Project  
**East West Rail  
(Western Section)  
Phase 2**

Drawing Title  
**PASSING PLACE A3\_P\_9  
GENERAL ARRANGEMENT**

### Stage 2 Road safety audit response report

### Offline Highways Passing Places – Package 2 – Oxfordshire (A3 Marsh Gibbon – Compound Access)

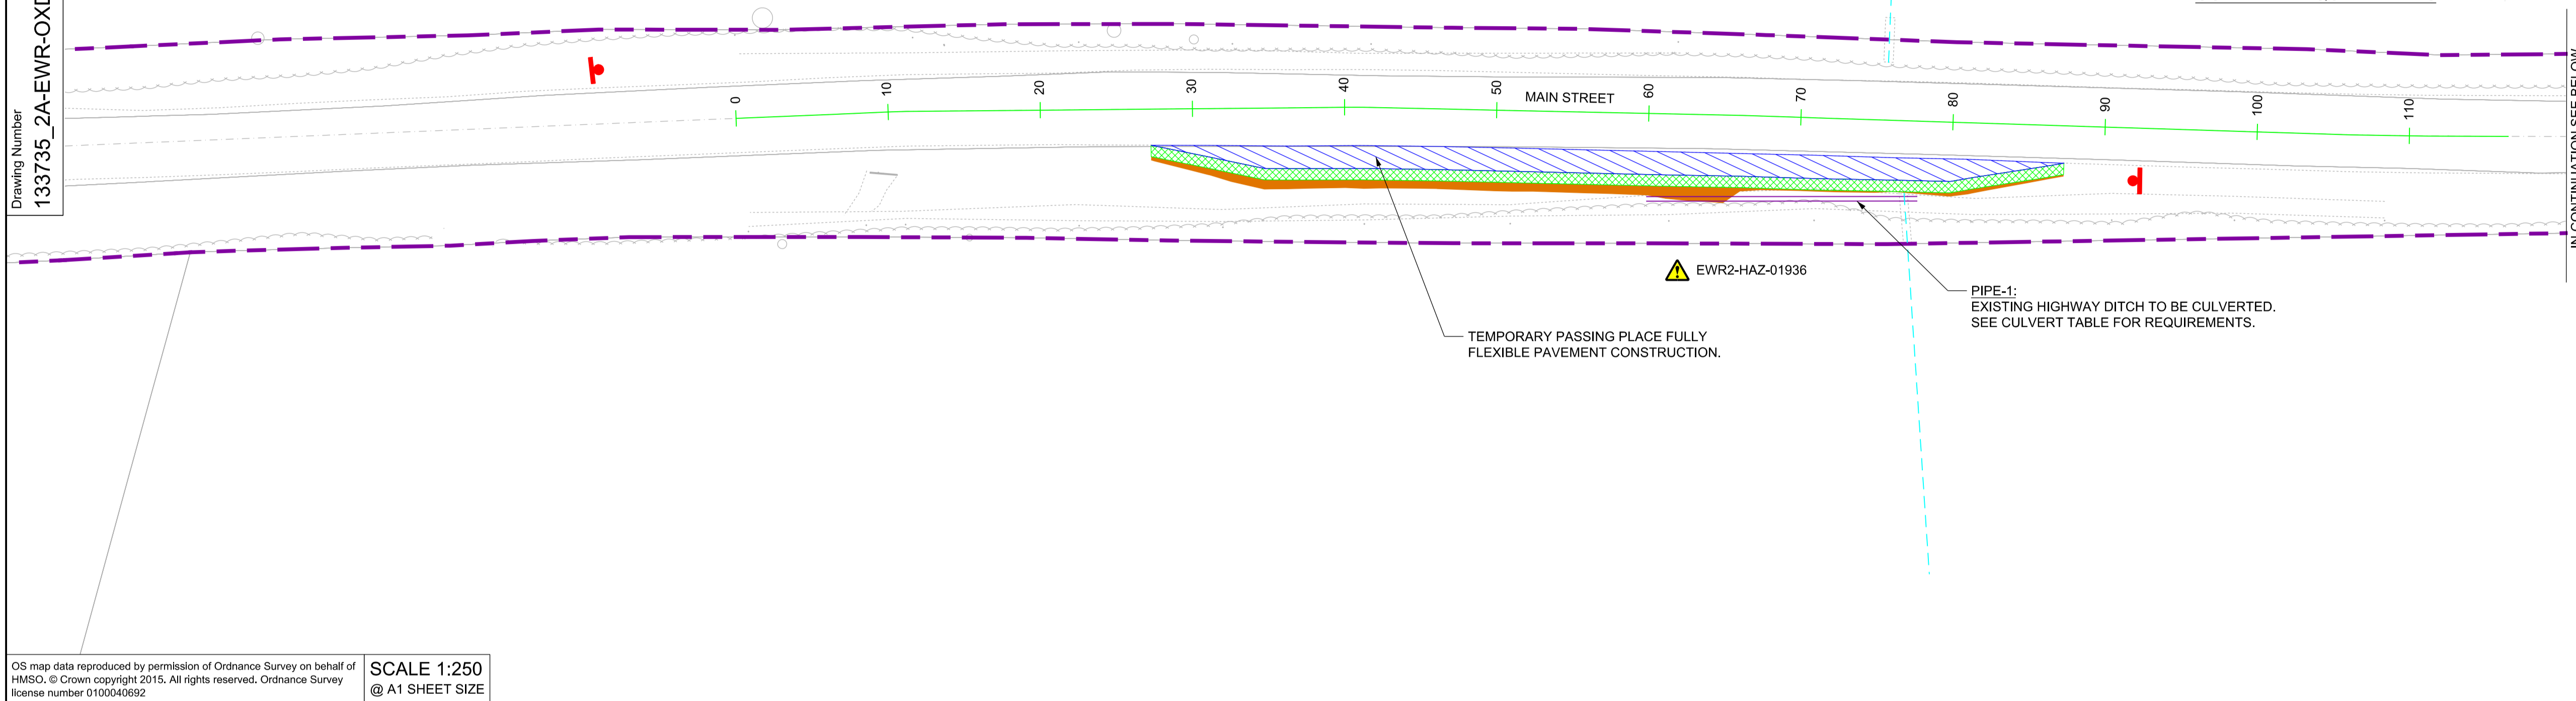
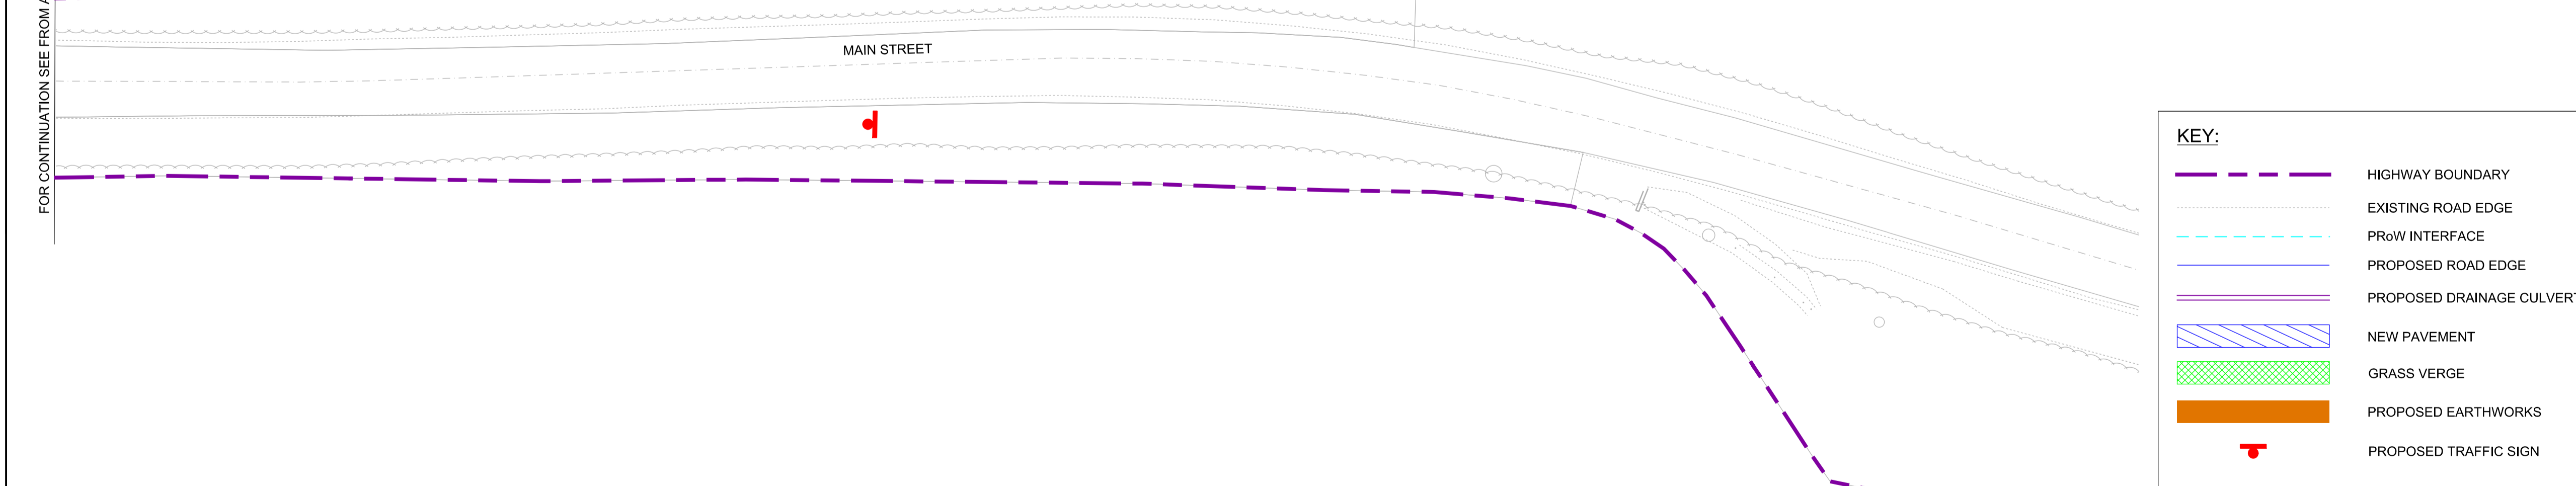
**Location:** Passing Places A3-P-2, A3-P-5 and A3-P-9.  
Unnamed Road (towards Mill Road).

There are access to public footpaths directly from Unnamed Road (towards Mill Road) in the nearside verges just before the proposed passing places A3-P-2 and A3-P-5. The proposed location of passing place A3-P-9 is directly between the accesses to public footpaths on the north and south sides of Unnamed Road (towards Mill Road), with the

passing place clashing with the access on the southern side. Due to the location of the passing places, there is an increased risk of a construction vehicle striking a pedestrian as they enter Unnamed Road (towards Mill Road), particularly as the construction vehicle will be preparing to enter the passing place. This issue is exacerbated by the lack of footway along Unnamed Road (towards Mill Road) as there is no segregation between vehicles and pedestrians.

**A3-P-9, Unnamed Road (towards Mill Road)** – Move passing place A3-P-9 further downstream heading westbound towards passing place A3-P-8. Provide traffic signing to warn pedestrians and construction vehicles of the passing place and presence of pedestrians, respectively. Trim back vegetation around the access to maximise visibility between pedestrians and drivers.

<p>A3-P-9, Unnamed Road (towards Mill Road) – Move passing place A3-P-9 further downstream heading westbound towards passing place A3-P-8. Provide traffic signing to warn pedestrians and construction vehicles of the passing place and presence of pedestrians, respectively. Trim back vegetation around the access to maximise visibility between pedestrians and drivers.</p>	<p><b>Accept the RSA problem raised but suggest an alternative solution.</b></p> <p>Passing place to remain in proposed position in accordance with TWAO. Traffic signing to warn vehicles of the presence of pedestrians in advance of the public right of way interface shall be provided, on the eastbound approach and before A3-P-9 and on the westbound approach and before A3-P-9. The site clearance drawings shall include vegetation clearance around the public right of way interface to maximise visibility for pedestrians and drivers. The RSA recommendations with respect to warning signage for pedestrians accessing the carriageway from a public right of way will be shared with the logistics team for inclusion.</p>	Accepted	Proceed as Design Team Response

Drawing Title  
**PASSING PLACE A3\_P\_9 EXISTING UTILITIES AND SITE CLEARANCE**

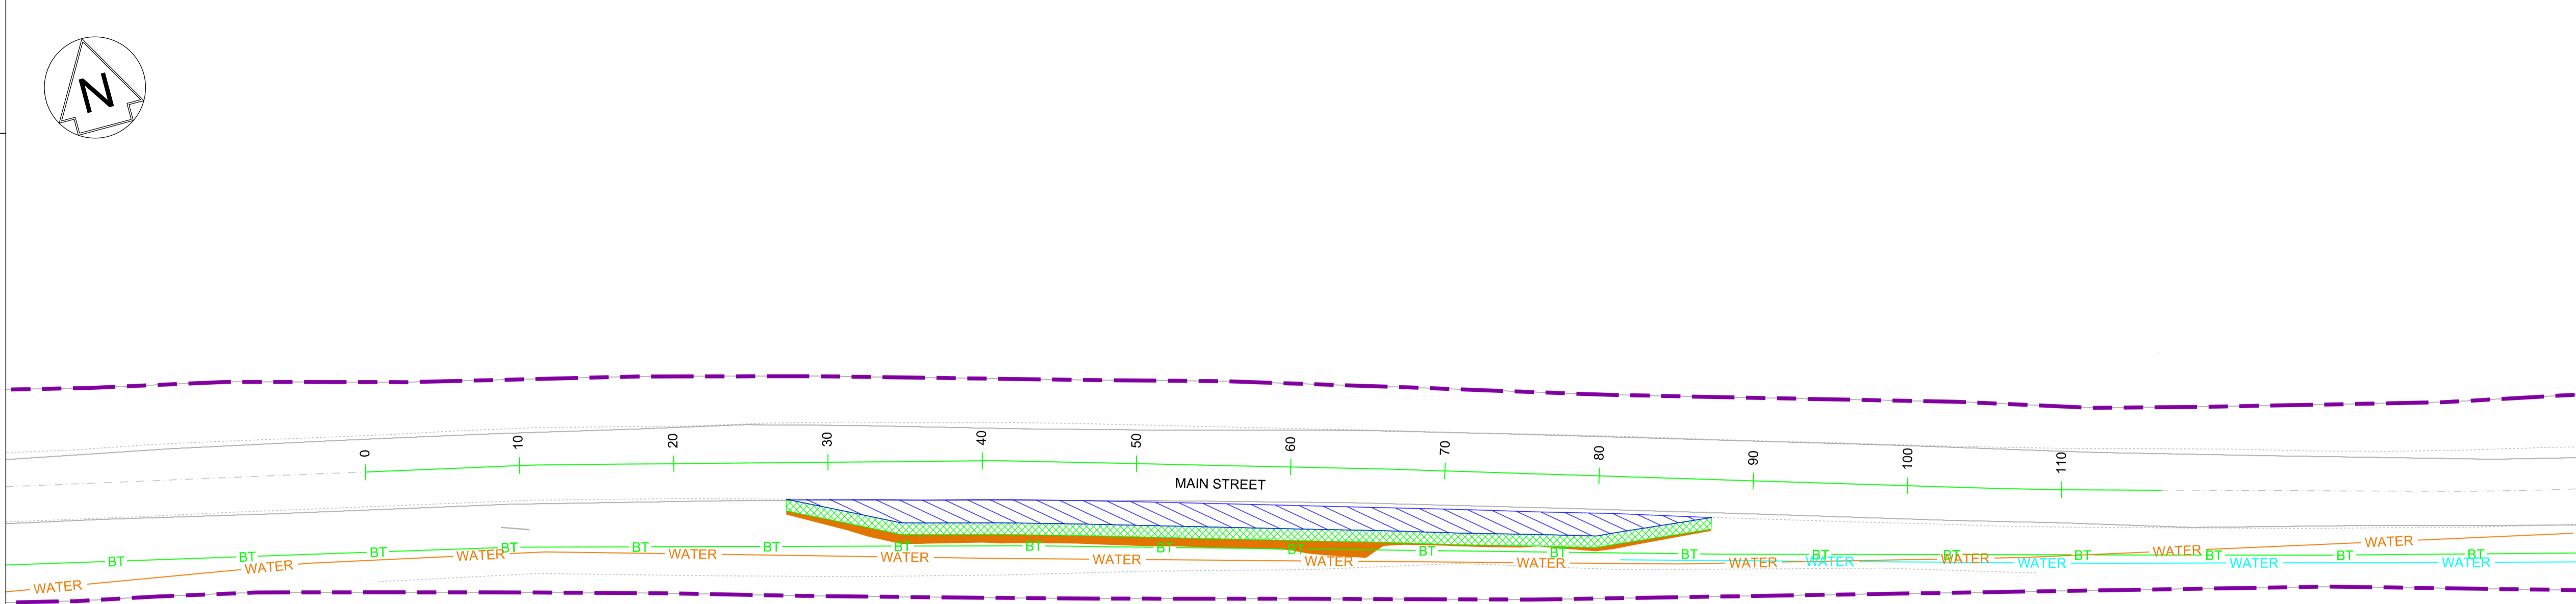
**Location:** Passing Places A2-P-2, A3-P-2, A3-P-3, A3-P-4, A3-P-5, A3-P-6, A3-P-7, A3-P-8, A3-P-9 and A3-P-10.

Passing places are proposed in positions where vegetation may restrict drivers' visibility of the route and the visibility of vehicles using the passing places. With this limitation, drivers of construction vehicles may not be aware that they should wait and might proceed, increasing the risk of side swipe collisions, or the risk of vehicles leaving the carriageway

The existing vegetation should be cut back to ensure clear visibility to all traffic signs and to keep the carriageway clear from obstructions.

2.5	<p>Passing Places A2-P-2, A3-P-2, A3-P-3, A3-P-4, A3-P-5, A3-P-6, A3-P-7, A3-P-8, A3-P-9 and A3-P-10. Unnamed Road (towards Mill Road) and Unnamed Road.</p>	<p><b>Driver visibility reduced by vegetation</b>                      Passing places are proposed in positions where vegetation may restrict drivers' visibility of the route and the visibility of vehicles using the passing places. With this limitation, drivers of construction vehicles may not be aware that they should wait and might proceed, increasing the risk of side swipe collisions, or the risk of vehicles leaving the carriageway on narrower sections of carriageway. Additionally, drivers of approaching vehicles may not anticipate the construction vehicle leaving the passing place, leading to side swipe or head on collisions. There is further risk that existing vegetation will encroach into the carriageway increasing the risk of damage to vehicles and HGVs being pushed towards oncoming traffic.</p>	<p>The existing vegetation should be cut back to ensure clear visibility to all traffic signs and to keep the carriageway clear from obstructions.</p>	<p><b>Accept the RSA problem and recommendation made by the RSA team.</b>                      The site clearance drawings include vegetation clearance to achieve required visibility and signage strategy drawings likewise include this provision.</p>	Accepted	Proceed as Design Team Response
